# Addendum

**Project:** Harris County Psychiatric Center Renovation  
Units 1C, 2E, 3B, 3C, 3D, & 3E

**Addendum No.:** 002

**Date:** November 14, 2016

**A2.02C**

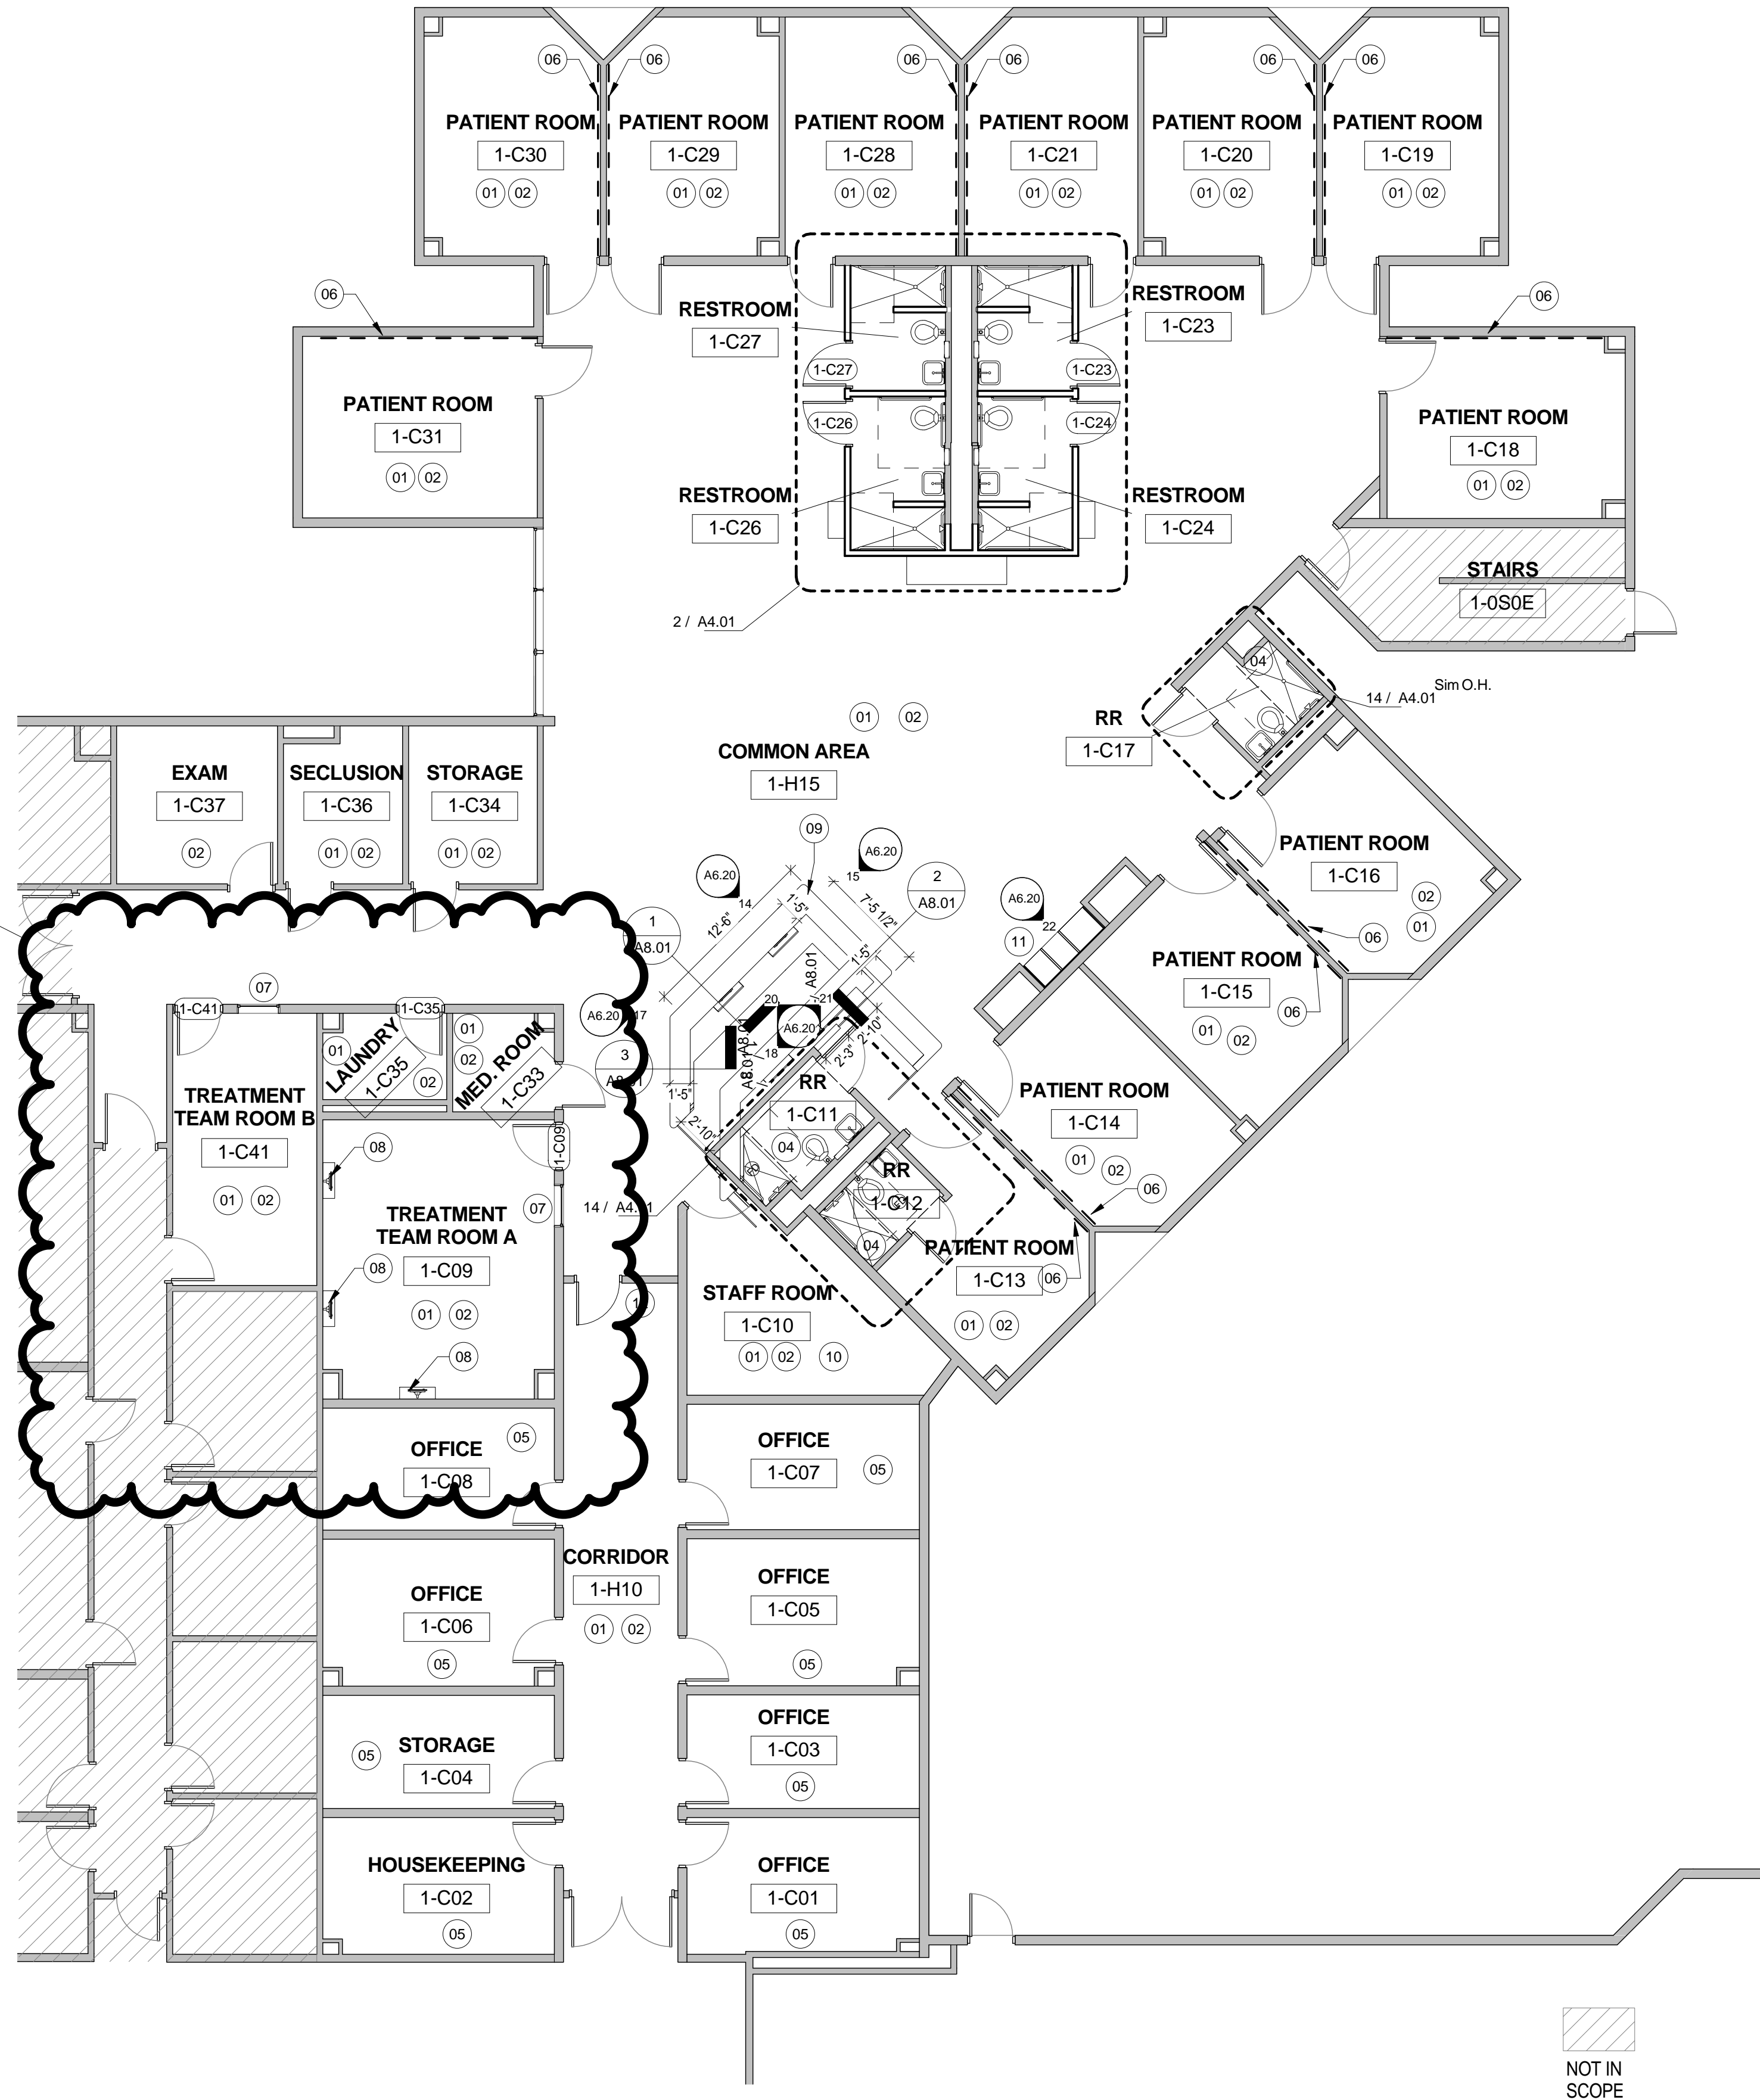
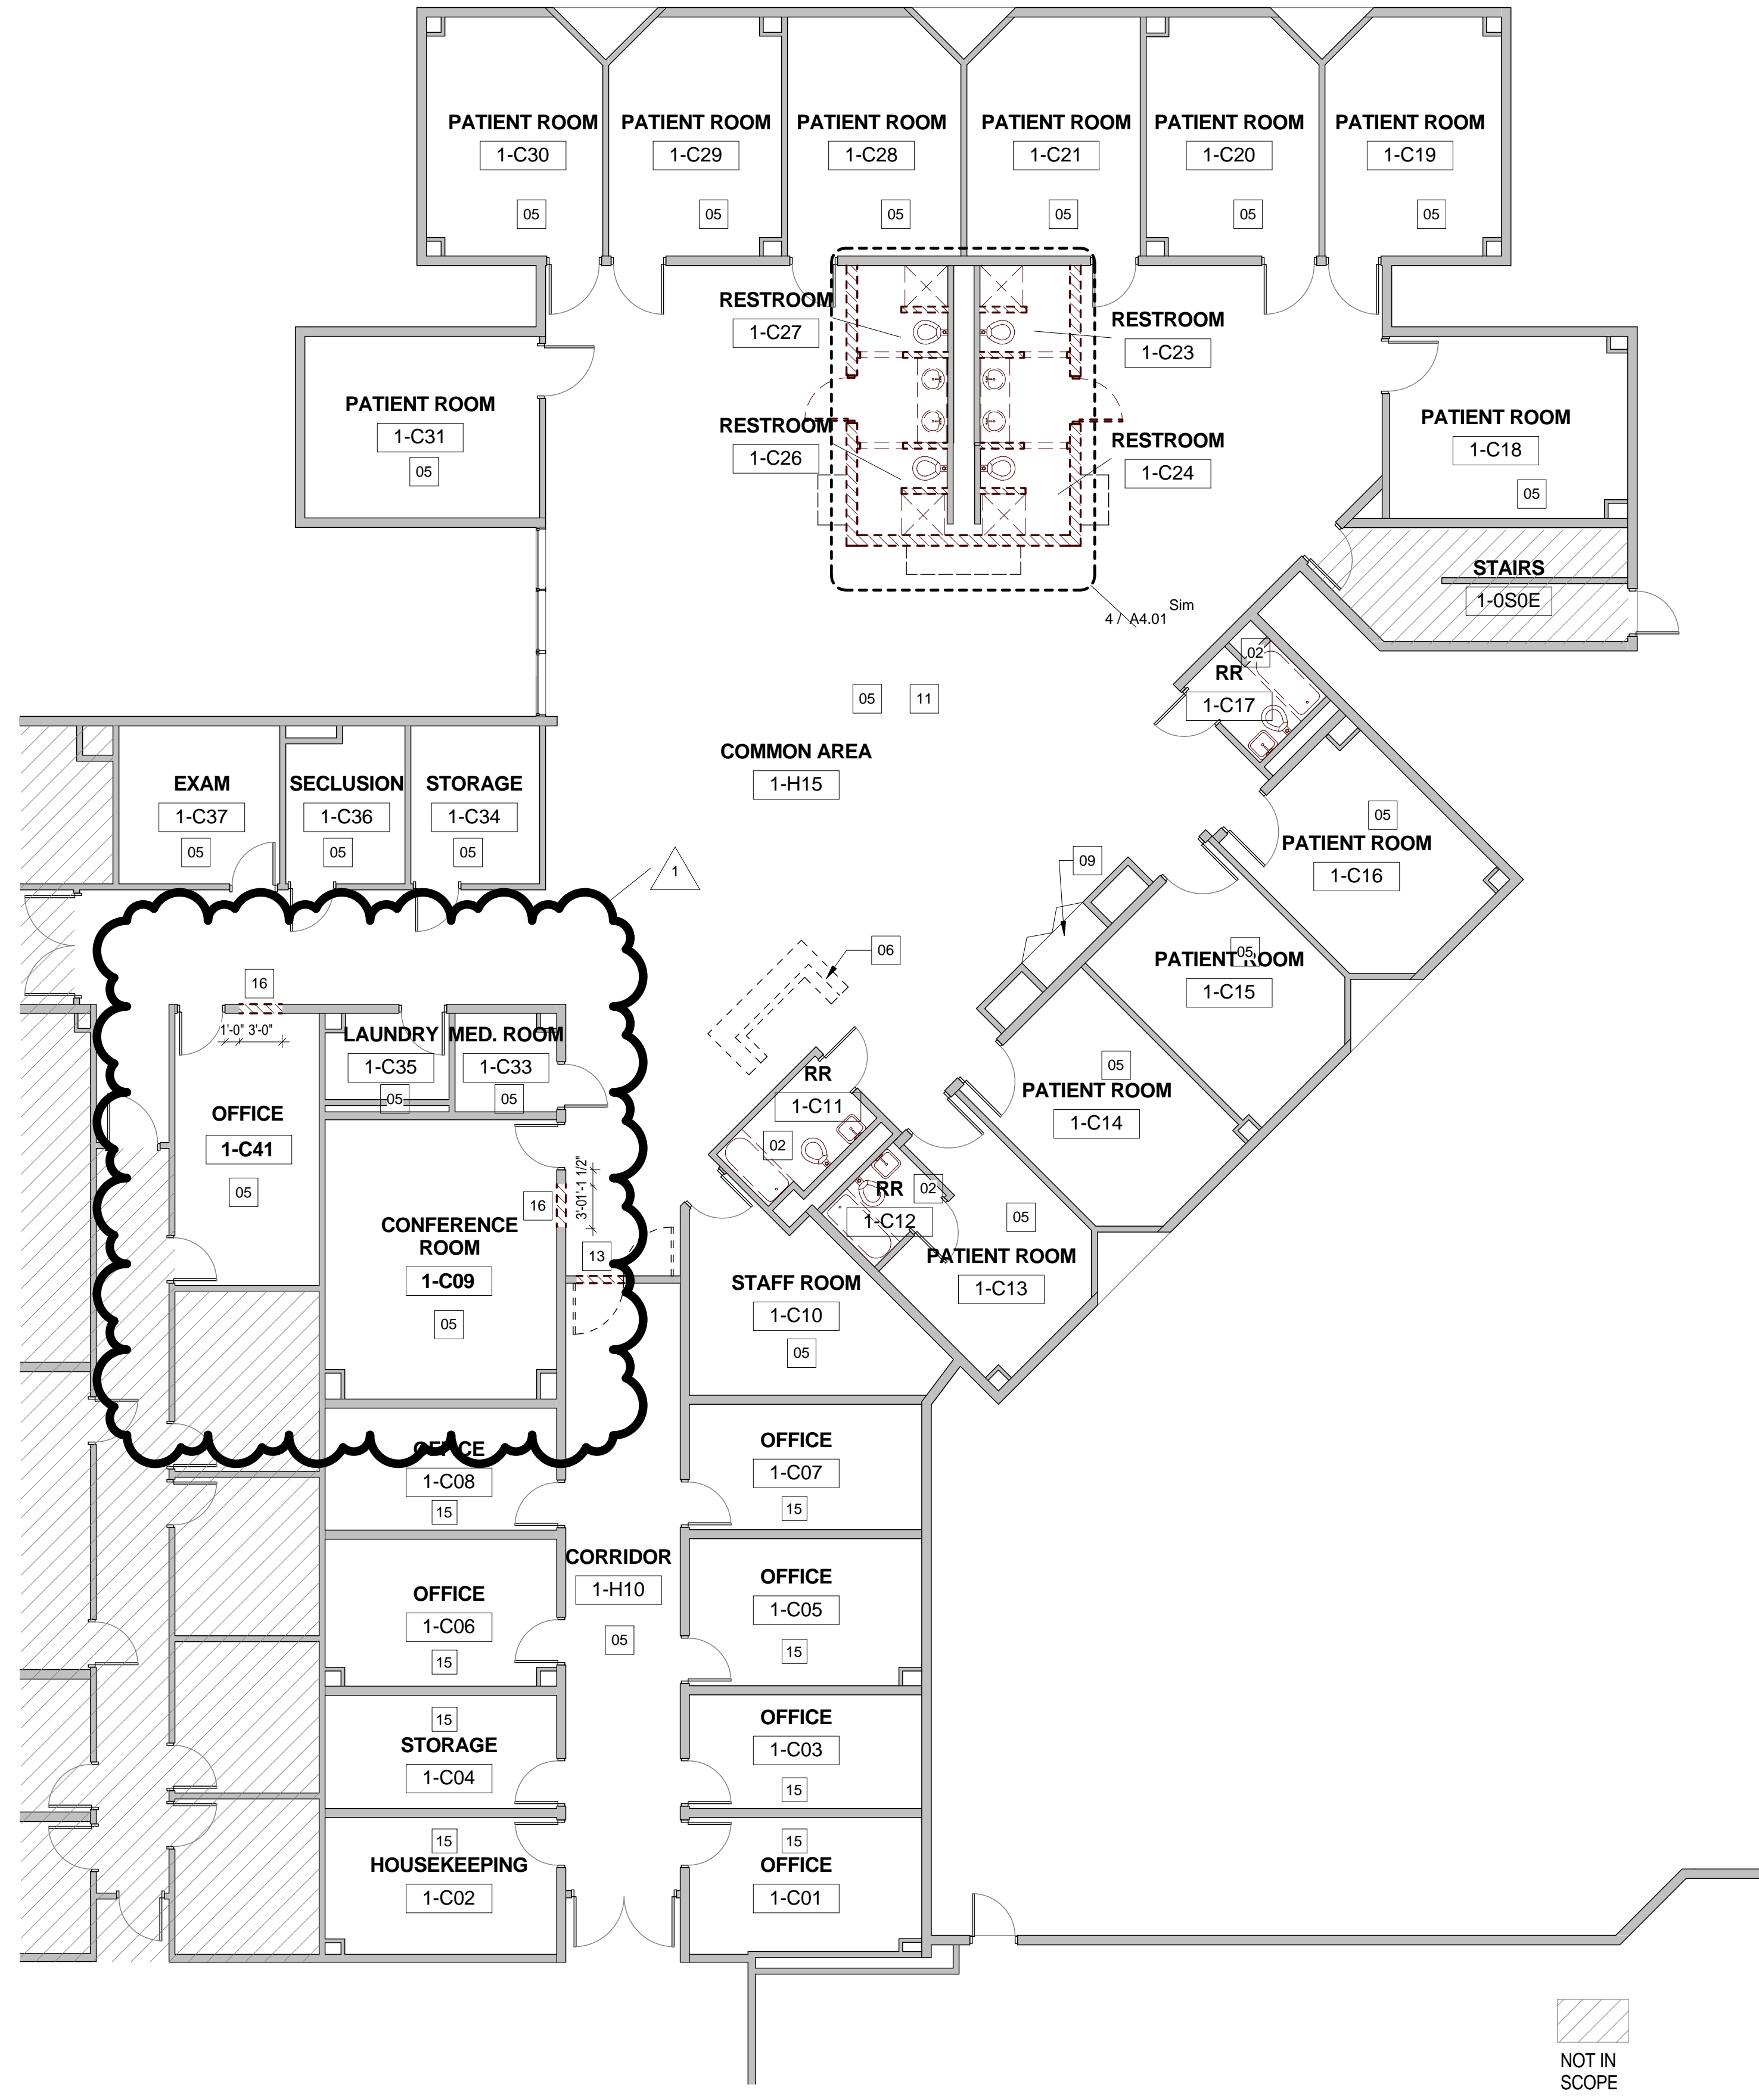
4. Sheet A2.02C, First Floor Unit 1C, revised to reflect changes to keyed notes on demolition and/or renovation plans. (see attached)
5. Sheet A2.05E, Second Floor Unit 2E, revised to reflect changes to keyed notes on demolition and/or renovation plans. (see attached)

**A2.08B**

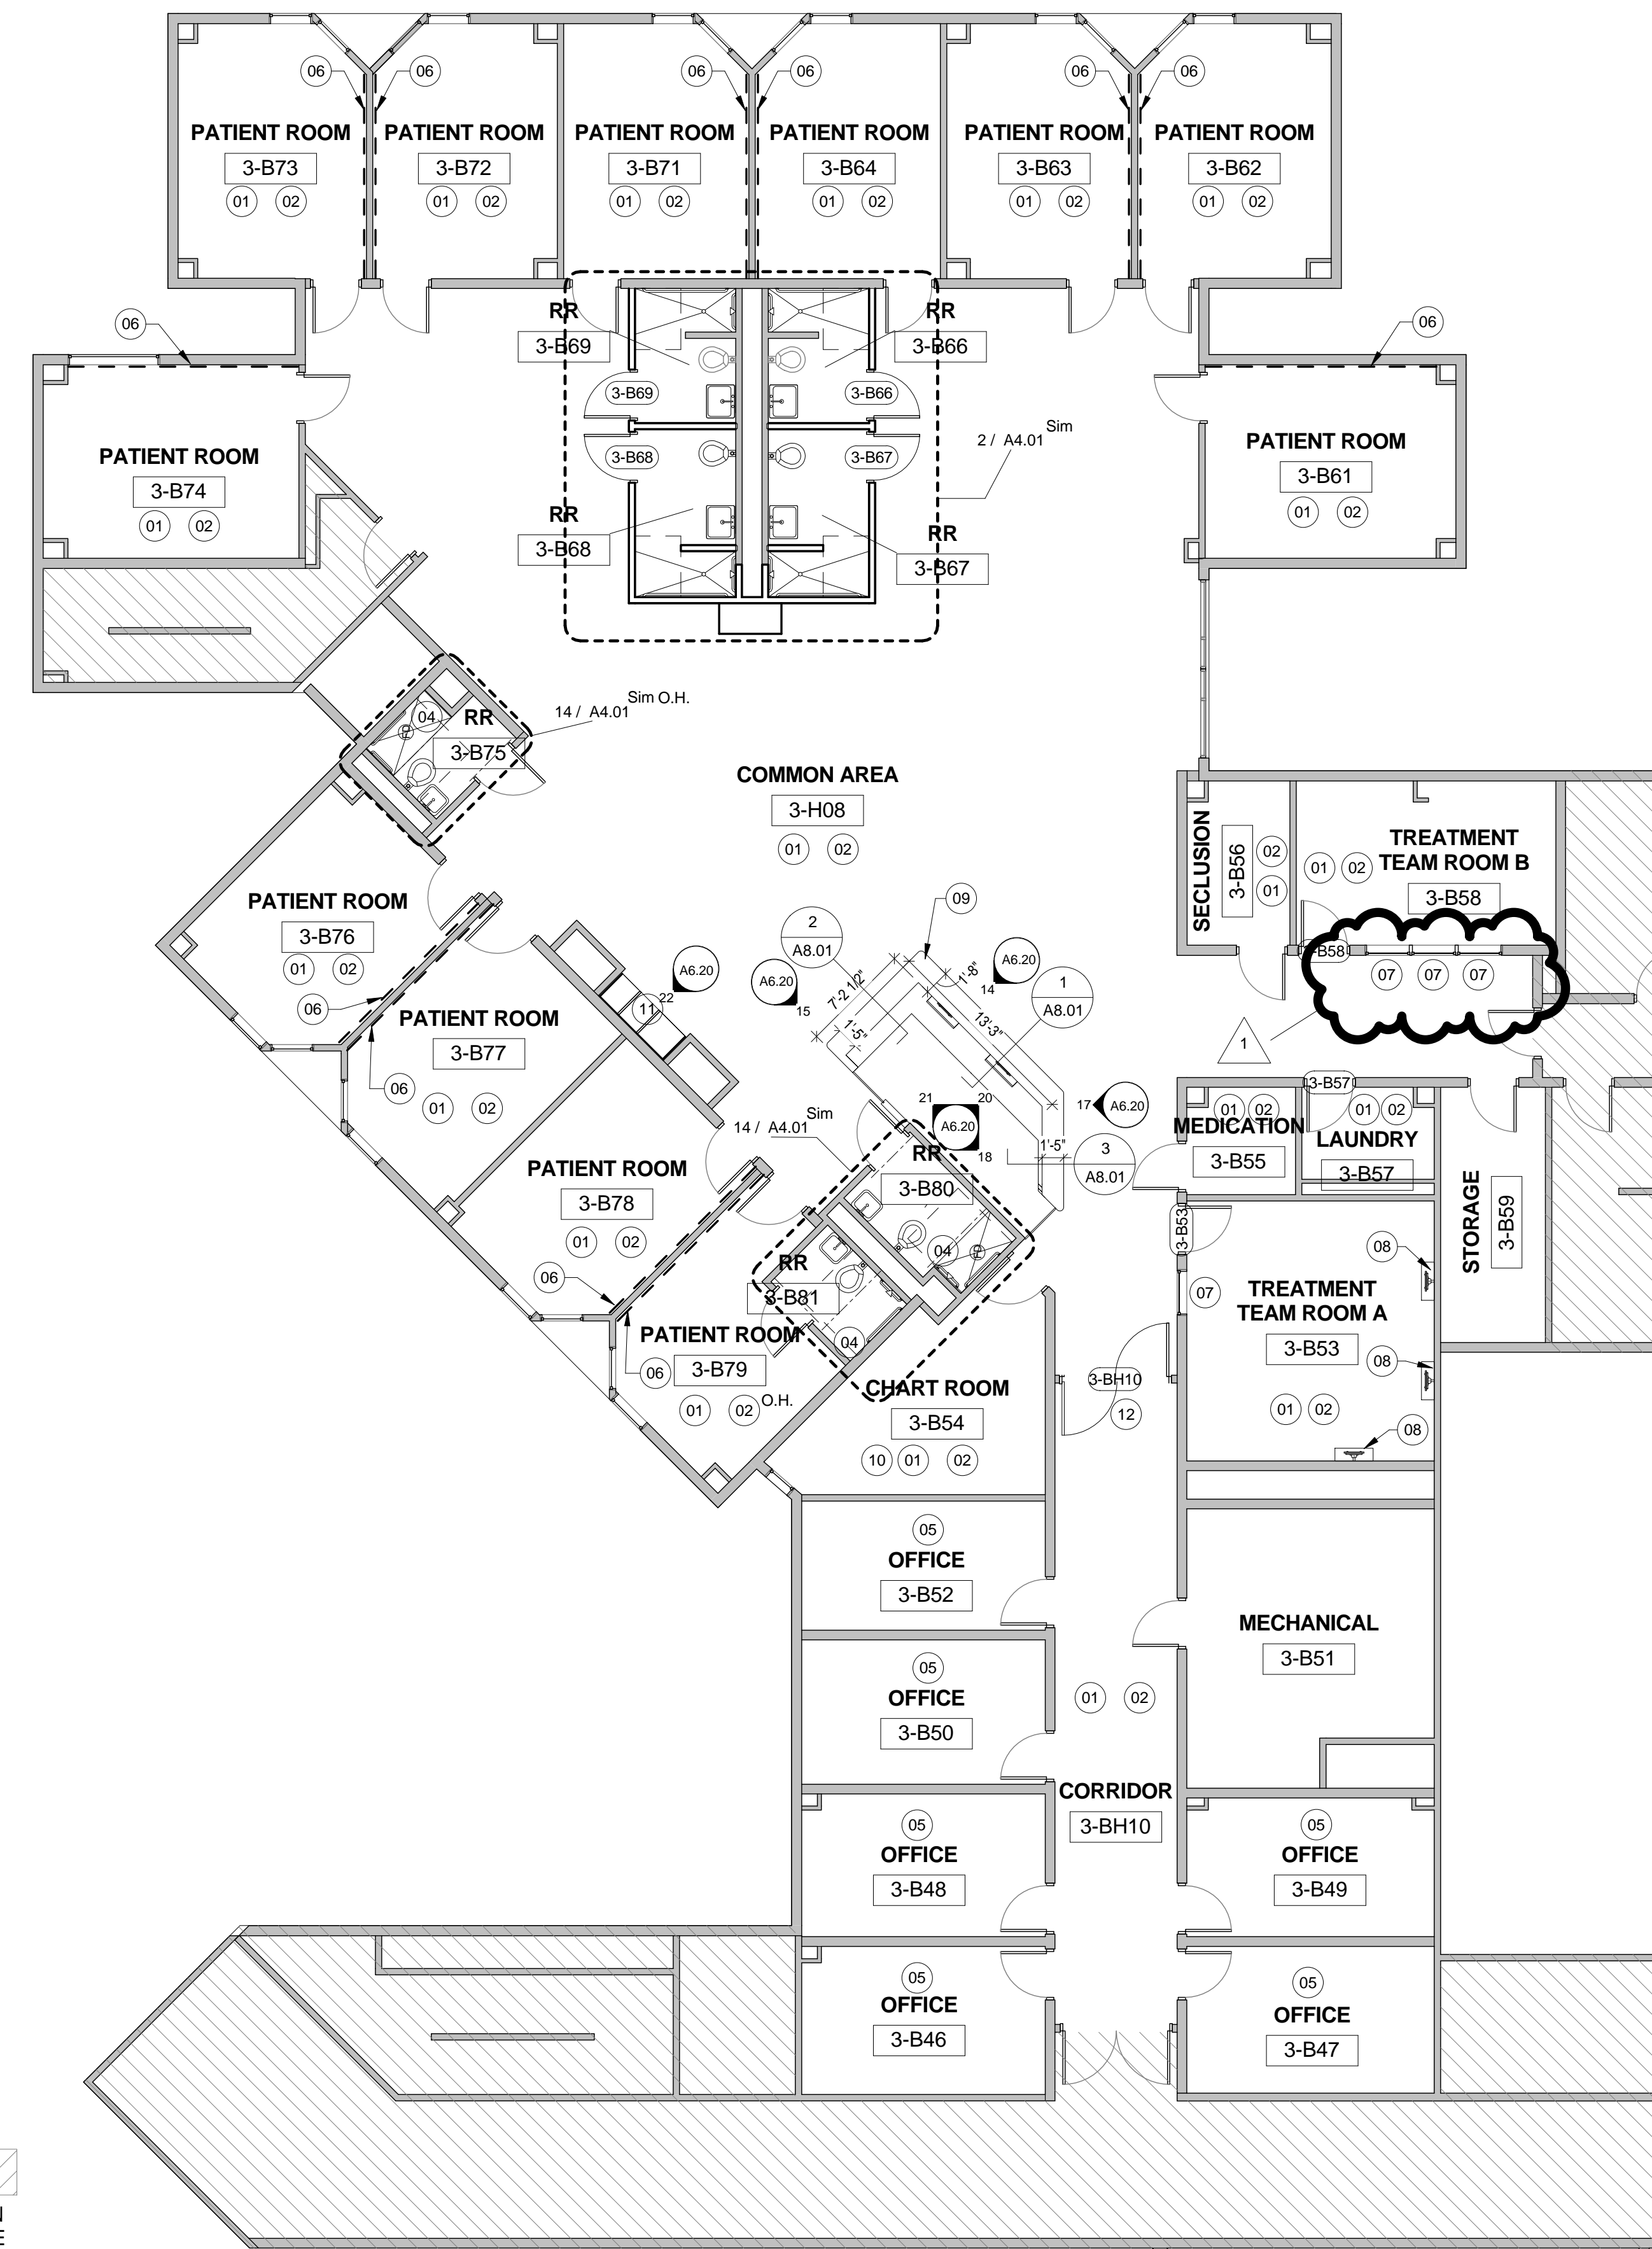
6. Sheet A2.08B, Third Floor Unit 3B, revised to reflect changes to keyed notes on demolition and/or renovation plans. (see attached)
7. Sheet A2.19C, First Floor Finish Plan – Unit 1C, revised to reflect changes to LVT-1 flooring specification and addition of flooring pattern(s) and grain direction(s) in Common Area. (see attached)
